**Town of Davidson  
Design Review Board Regular Meeting  
Town Hall and Community Center  
Community Room 120  
251 South Street  
Wednesday, April 15, 2026 at 5:30 PM**

## DESIGN REVIEW BOARD: STAFF REPORT

Date: April 15, 2026  
To: Design Review Board  
From: Lindsay Laird, Senior Planner  
Re: Summit Farms Bakey & Market Buildings – Formal Review & Recommendation

- **Project:** Summit Farms Conditional Planning Area
- **Location:** 19300 Shearer Rd (Parcel IDs 00723103, 00723121, 00723115, & 00723116)
- **Applicant:** Summit Farms, LLC
- **Designer:** Redline Design Group
- **Planning Area:** Conditional (Underlying zoning is Neighborhood Services Overlay District)

A6.0

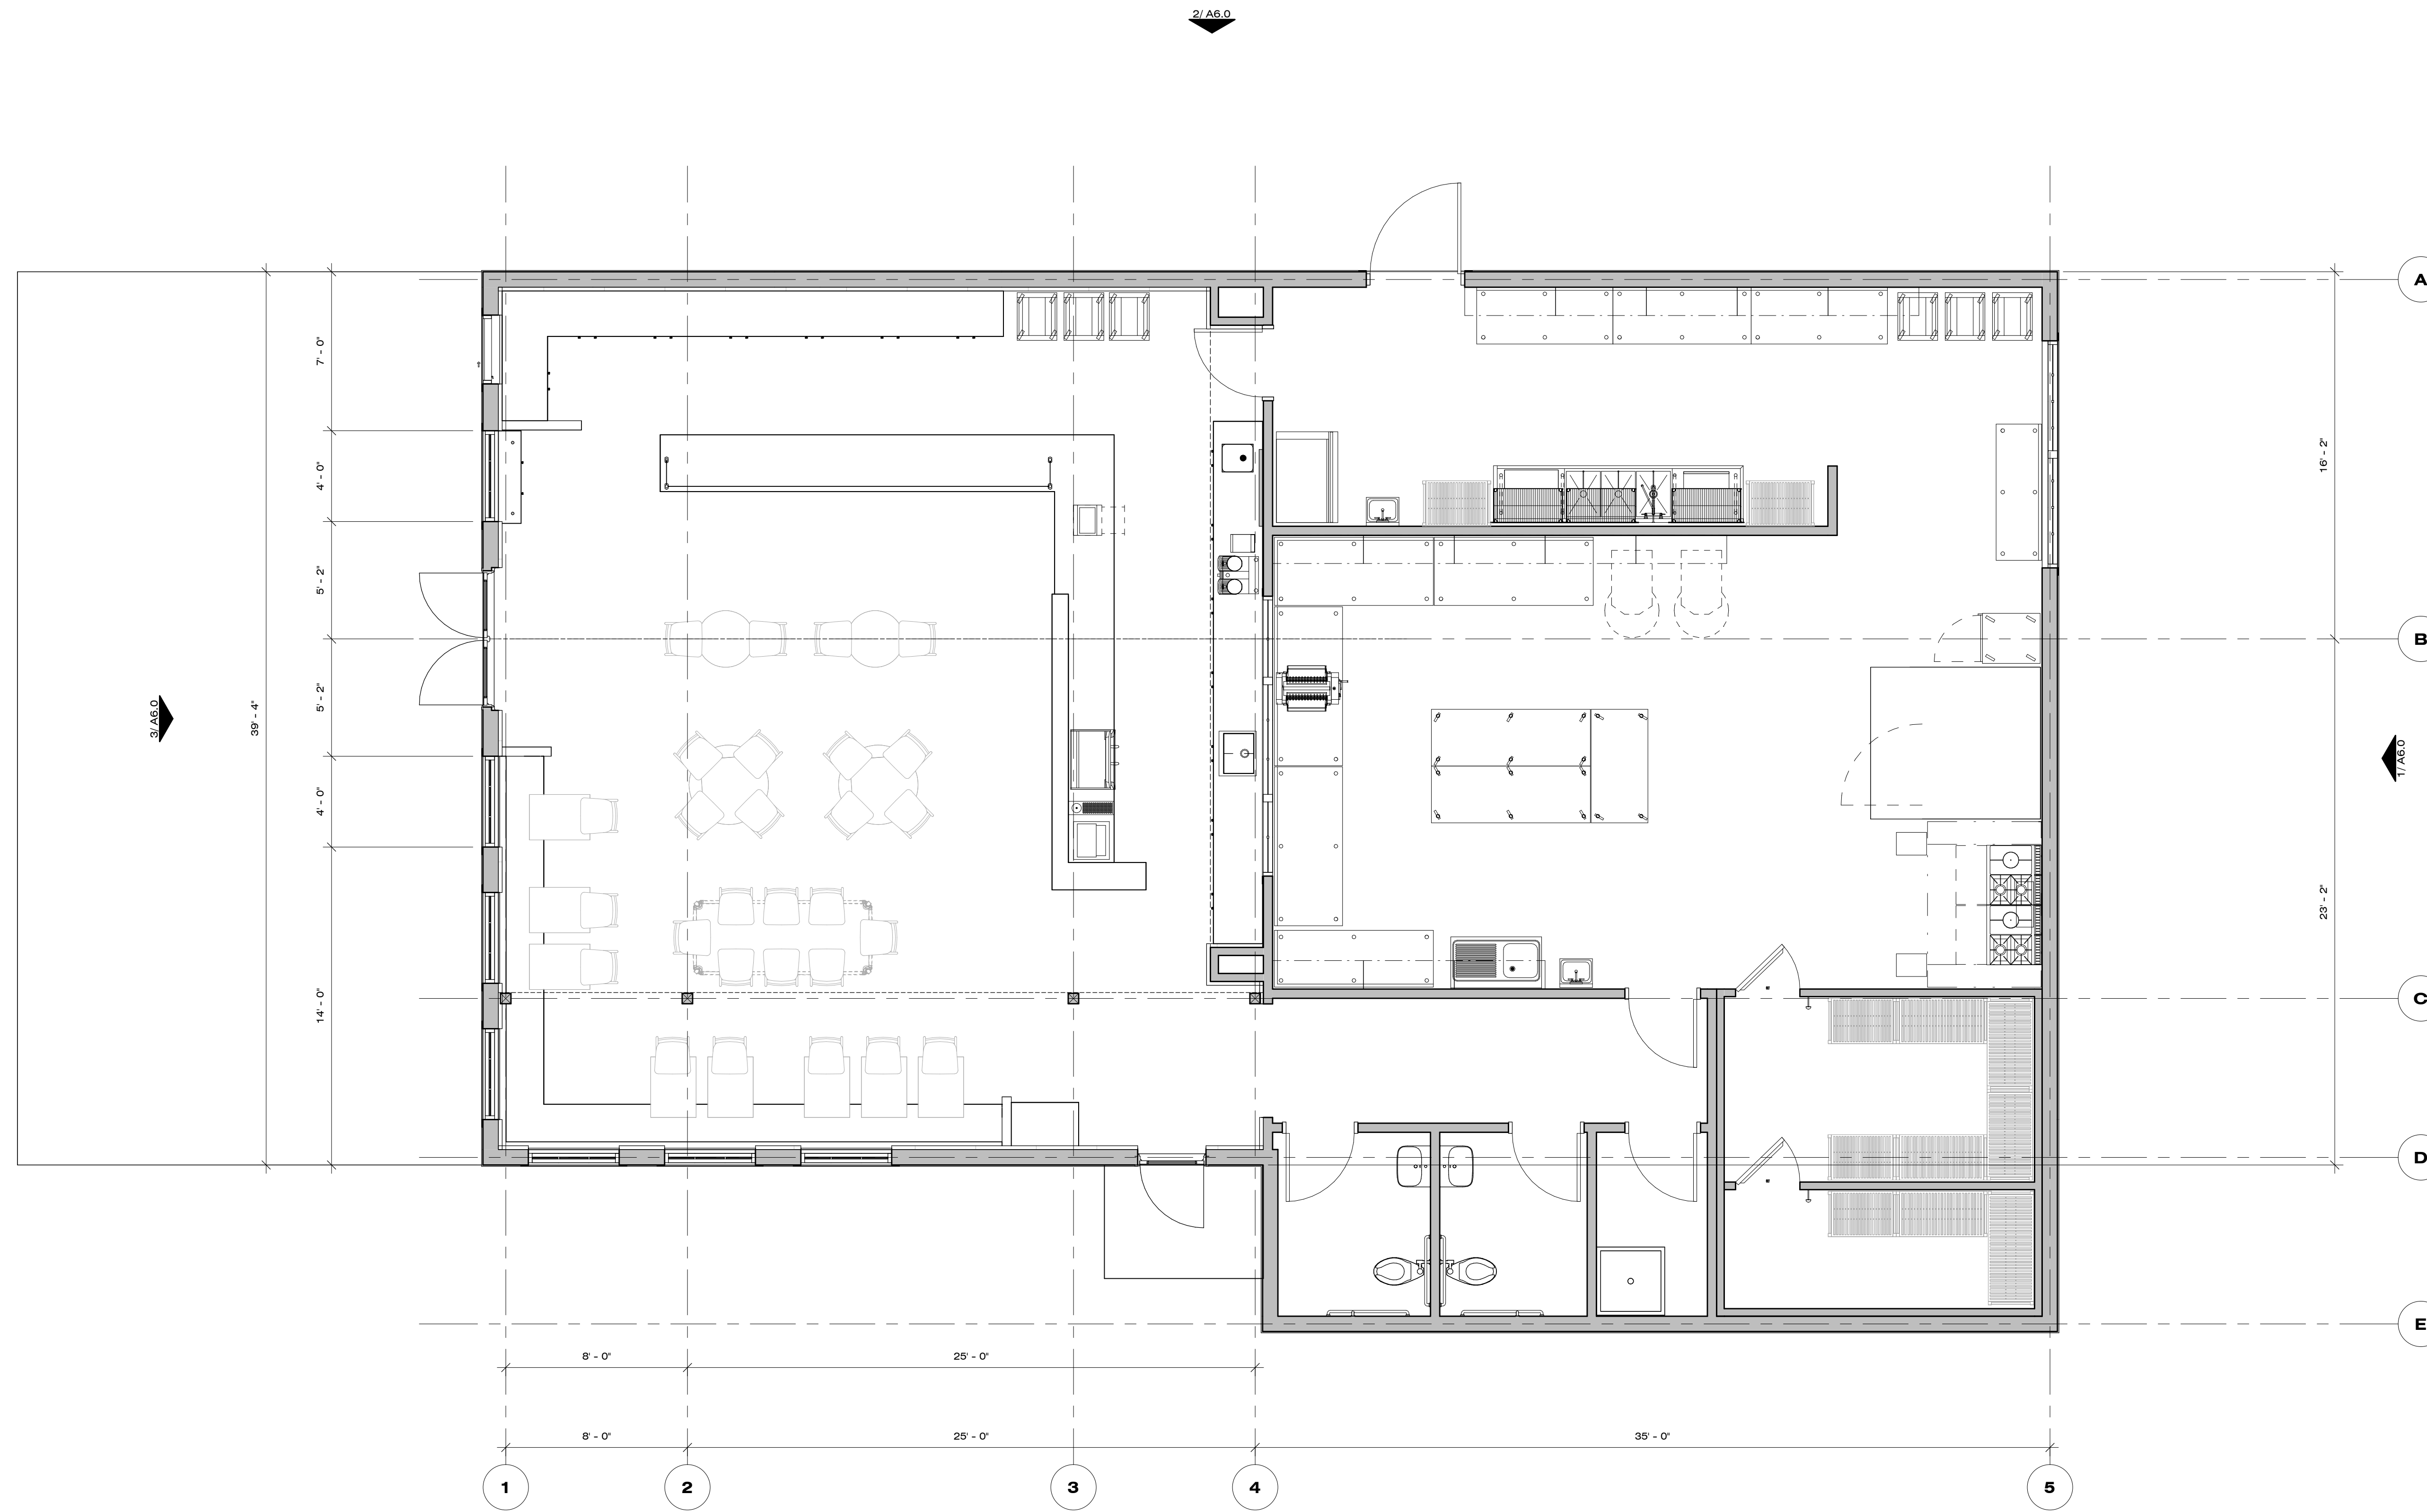
- **Façade Articulation:** Consider adding more of a base to the bakery building.
- **Bakery Canopy:** The canopy and brackets are oversized. Consider using smaller brackets at canopy above entrance.
- **Faux Building Elements:** Faux windows and doors are prohibited. Remove faux shuttered windows from Shearer Rd elevation of bakery building and consider articulating this façade with another element such as a landscape wall.
- **Gutters & Downspouts:** Add gutters and downspouts to dormers of market building.
